ACCESSIBILITY ASSESSMENT

ADA TITLE III ASSESSMENT

Gateways High School

December 13, 2024

Map for Barrier ID: AX519183

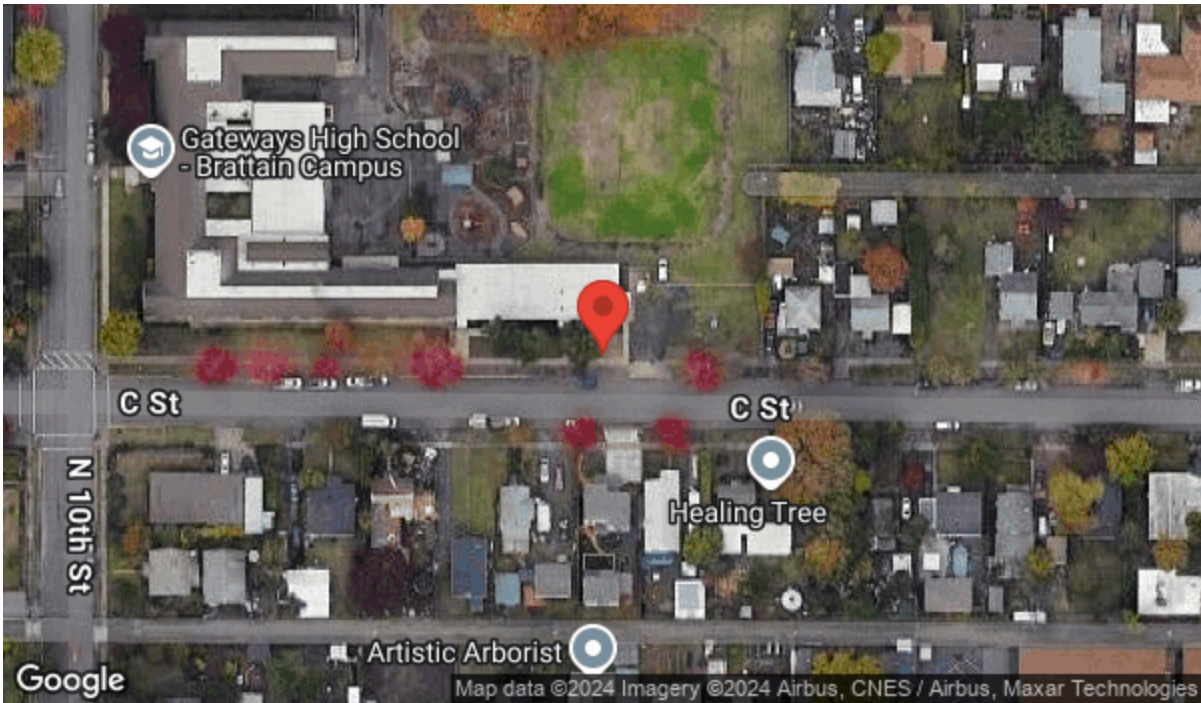
Assembly	Exterior Access Route
Type	Exterior Accessible Route
ADA Standard	403.3
Barrier Detail	The accessible route has cross slopes greater than 1:50 (2%).
Location Description	Accessible Route - West Sidewalk
Observed	Nov 6, 2024 by Jeffrey.solis@bureauveritas.com

The walkway should be graded to a maximum 1:50 (2%) cross slope. An accessible route has maximum 1:20 (5%) running slope and maximum 1:50 (2%) cross slope. [EXCEPTION: Cross slopes not exceeding 1:48 (2.08%) are permitted.] The clear width of walking surfaces shall be 36" minimum. [EXCEPTION: The clear width shall be permitted to be reduced to 32" minimum for a length of 24" maximum provided that reduced width segments are separated by segments that are 48" long minimum and 36" wide minimum.] Where grading to maximum running slope of 1:20 (5% running slope) is not possible, provide a compliant ramped surface within the walkway with maximum slope 1:12 (8.33%) and maximum ramp run rise of 6" without handrails. If a ramped surface with running slopes greater than 1:20 (5%) and maximum 1:12 (8.33%) rises more than 6", handrails are required. The cost estimate for this barrier removal is based on grading the running slope to maximum 1:20 (5%). The quantity and order of magnitude cost estimate provided for this barrier are limited to the extent of the area identified as non-compliant. Additional costs that may be associated with removal of the barrier are not included.

Photos for Barrier ID: AX519128

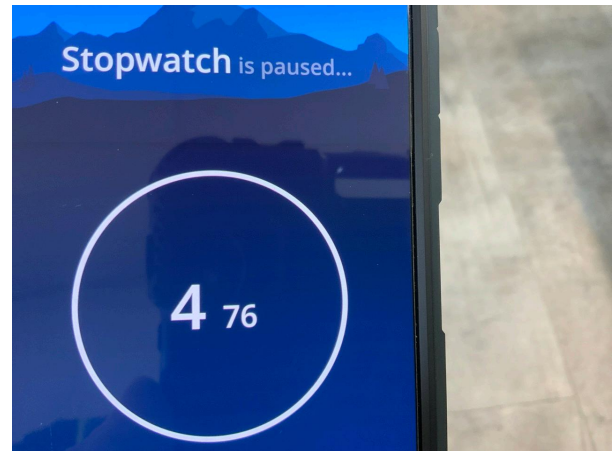
Assembly	Entrance to Building	
Type	Building Entrance - Door	
ADA Standard	404.2.5	
Barrier Detail	The threshold at the accessible door is greater than ½" in height.	
Location Description	Cosmetology Classroom	
Observed	Nov 6, 2024 by Jeffrey.solis@bureauveritas.com	
Site Conditions	The threshold at the accessible door is 9/16" in height.	
Resolution	<p>Remove and replace with a threshold that is ½" or less in height (including carpet pile allowed to be 1/2" max high). Thresholds, if provided at doorways, shall be 1/2" high maximum. Raised thresholds and changes in level at doorways shall be compliant. [EXCEPTION: Existing or altered thresholds 3/4" high maximum that have a beveled edge on each side with a slope not steeper than 1:2 shall not be required to comply.]</p>	
Quantity	Unit Cost	Total Cost
1 EA	308.78	\$ 309
Priority	1

Photos for Barrier ID: AX519117

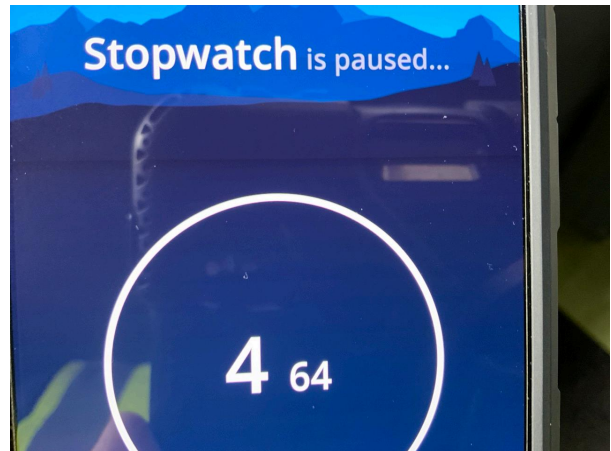
Assembly	Entrance to Building	
Type	Building Entrance-Door	
ADA Standard	Oregon Structural Specialty Code 1102.1.2.	
Barrier Detail		
OREGON: The hinged accessible exterior door requires more than 8.5 pounds of pressure to operate		
Location Description	Gym	
Observed	Nov 6, 2024 by Jeffrey.solis@bureauveritas.com	
Site Conditions	The door opening force is 9.5 pounds.	
Resolution		
Adjust the closer or replace with an exterior door that requires no more 8.5 pounds of force for pushing or pulling the door open. The opening force of doors along an accessible route shall be as follows: 1. Exterior doors: 8.5 pounds maximum (lbf) (37.8 N). 2. Interior doors: 5 pounds maximum (lbf) (22.2 N). 3. Stairway doors at pressurized stair enclosures: 15 pounds maximum (6.8 kg) at exterior doors. 4. Where environmental conditions require greater closing pressure, power-operated doors shall be used within the accessible route. [Exception: The force required to retract latch bolts or disengage other devices that hold the door or gate in a closed position shall not apply to panic hardware, delayed egress devices or fire-rated hardware.]

Photos for Barrier ID: AX519084

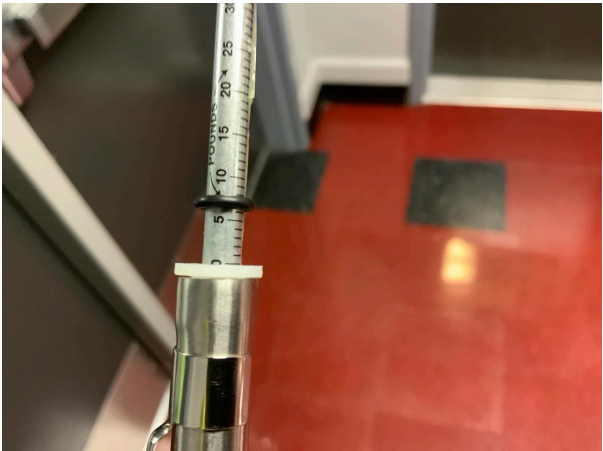
Assembly	Interior Access Route
Type	Door
ADA Standard	404.2.9
Barrier Detail	
The opening force required to open the accessible, hinged, non-fire door is more than 5 pounds.	
Location Description	Main - Offices
Observed	Nov 6, 2024 by Jeffrey.solis@bureauveritas.com
Site Conditions	The door opening force is 7 pounds.

Adjust the closer or replace with a door that requires no more than 5 pounds of force for pushing or pulling the door open. This barrier must be removed in conjunction with barrier ID 519086. The force at the latch, the force to set the door in motion, and the force to fully open the door shall be maximum 5 pounds. These forces do not apply to the force required to retract latch bolts or disengage other devices that hold the door or gate in a closed position.

Photos for Barrier ID: AX519152

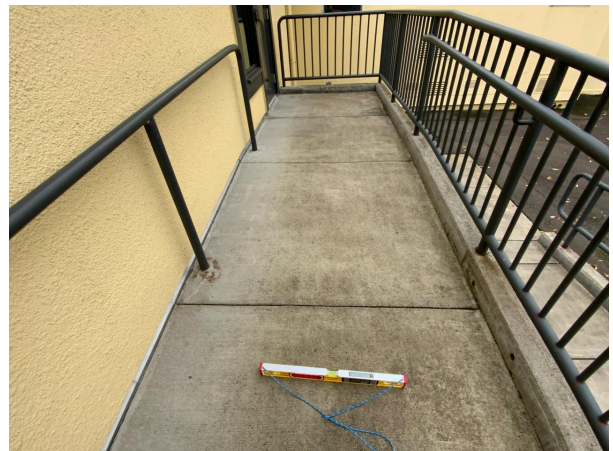
Assembly	Exterior Access Route	
Type	Ramp	
ADA Standard	505.6	
Barrier Detail	The handrail height is not compliant.	
Location Description	Ramp R-2	
Observed	Nov 6, 2024 by Jeffrey.solis@bureauveritas.com	
Site Conditions	The top of the gripping surface of the handrail measures 30” above the nosing.	
Handrail Height	30"	
Resolution	The top of the gripping surface of the handrail shall be 34" minimum and 38" maximum vertical above ramp surfaces. Handrails shall be at a consistent height above ramp surfaces. Provide compliant handrails on both sides of the ramp. The handrails on each side shall be a minimum 36" apart horizontally. The top of the gripping surface of the handrail shall be 34" minimum and 38" maximum vertical above ramp surfaces. Handrails shall be at a consistent height above ramp surfaces. The gripping surface of handrails shall be 1.25" to 2" diameter, or a non-circular grip that has a perimeter dimension of 4" to 6.25" maximum. Handrails shall be provided on both sides of ramps. Provide a bottom rail that is maximum 4" from the ramp surface and prevents the passage of a 4" diameter sphere between the ramp surface and the rail.

Photos for Barrier ID: AX519154

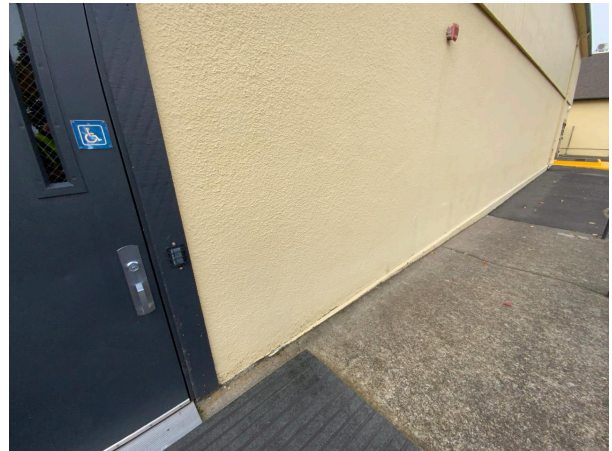
Assembly	Exterior Access Route	
Type	Ramp	
ADA Standard	405.2	
Barrier Detail		
The ramp has a running slope in excess of 1:12 (8.33%) and/or cross slope in excess of 1:48 (2.08%).		
Location Description	Ramp R-3	
Observed	Nov 6, 2024 by Jeffrey.solis@bureauveritas.com	
Site Conditions	The ramp has a running slope of 9.2% to 12.0%, and a cross slope of 2.3%.	
Highest Running Slope	12%	
Lowest Running Slope	9.2%	
Highest Cross Slope	2.3%	
Resolution		
Remove the existing ramp and provide a compliant ramp. Ramp runs shall have a running slope not steeper than 1:12 (8.33%). [EXCEPTION: In existing sites, buildings, and facilities built before January 1992, ramps shall be permitted to have running slopes steeper than 1:12 where such slopes are necessary due to space limitations. Where slopes are steeper than 1:10 but not steeper than 1:8, the rise shall be 3" maximum. Where slopes are steeper than 1:12 but not steeper than 1:10, the rise shall be 6" maximum.] Ramp runs shall have cross slopes not greater than 1:50 (2%). [EXCEPTION: Cross slopes not greater than 1:48 (2.08%) are permitted.] Either regrade to a maximum running slope of 1:20 (5%) for the walking surface, or provide a compliant ramp. The cost estimate for this barrier removal is based on providing a compliant ramp. The quantity and order of magnitude cost estimate provided for this barrier are limited to the extent of the area identified as non-compliant. Additional costs that may be associated with removal of the barrier are not included.

Photos for Barrier ID: AX519156

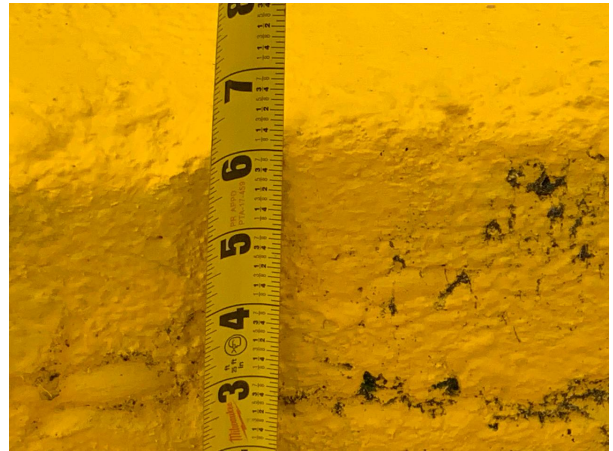
Assembly	Exterior Access Route
Type	Stairs
ADA Standard	505.10
Barrier Detail	Handrail extensions are not compliant.
Location Description	Stair ST-5
Observed	Nov 6, 2024 by Jeffrey.solis@bureauveritas.com

Photos for Barrier ID: AX519161

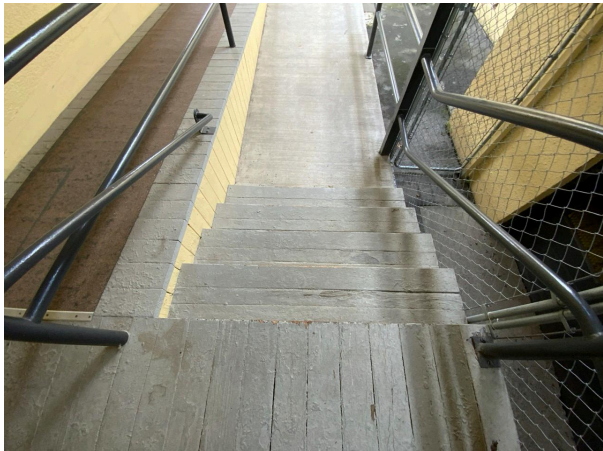
Assembly	Exterior Access Route
Type	Stairs
ADA Standard	505.10
Barrier Detail	Handrail extensions are not compliant.
Location Description	Stair ST-6
Observed	Nov 6, 2024 by Jeffrey.solis@bureauveritas.com

Photos for Barrier ID: AX519168

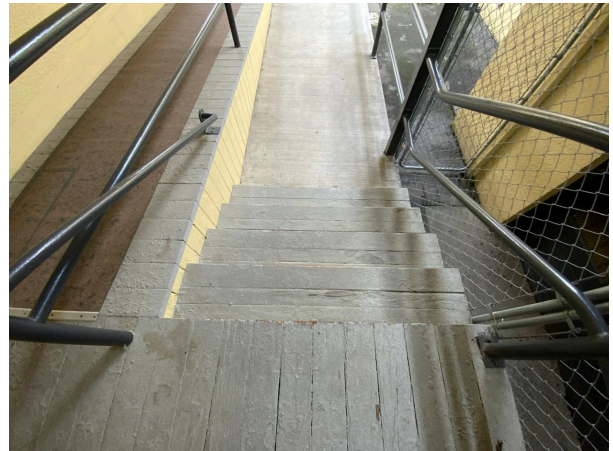
Assembly	Exterior Access Route	
Type	Stairs	
ADA Standard	2009 ANSI A117.1-504.5.1	
Barrier Detail		
OREGON: The stair treads do not have visual contrast of dark-on-light or light-on-dark on the leading 2" of the tread from the remaining portion of the tread surface.		
Location Description	Stair ST-8	
Observed	Nov 6, 2024 by Jeffrey.solis@bureauveritas.com	
Site Conditions		
The stair treads do not have visual contrast of dark-on-light or light-on-dark on the leading 2" of the tread from the remaining portion of the tread surface.		
Resolution		
Provide light-on-dark or dark-on-light visual contrast on the leading 2" of each tread, in contrast with the remaining portion of the tread surface.		
Quantity	Unit Cost	Total Cost
1 EA	60.72	\$ 61
Priority	3
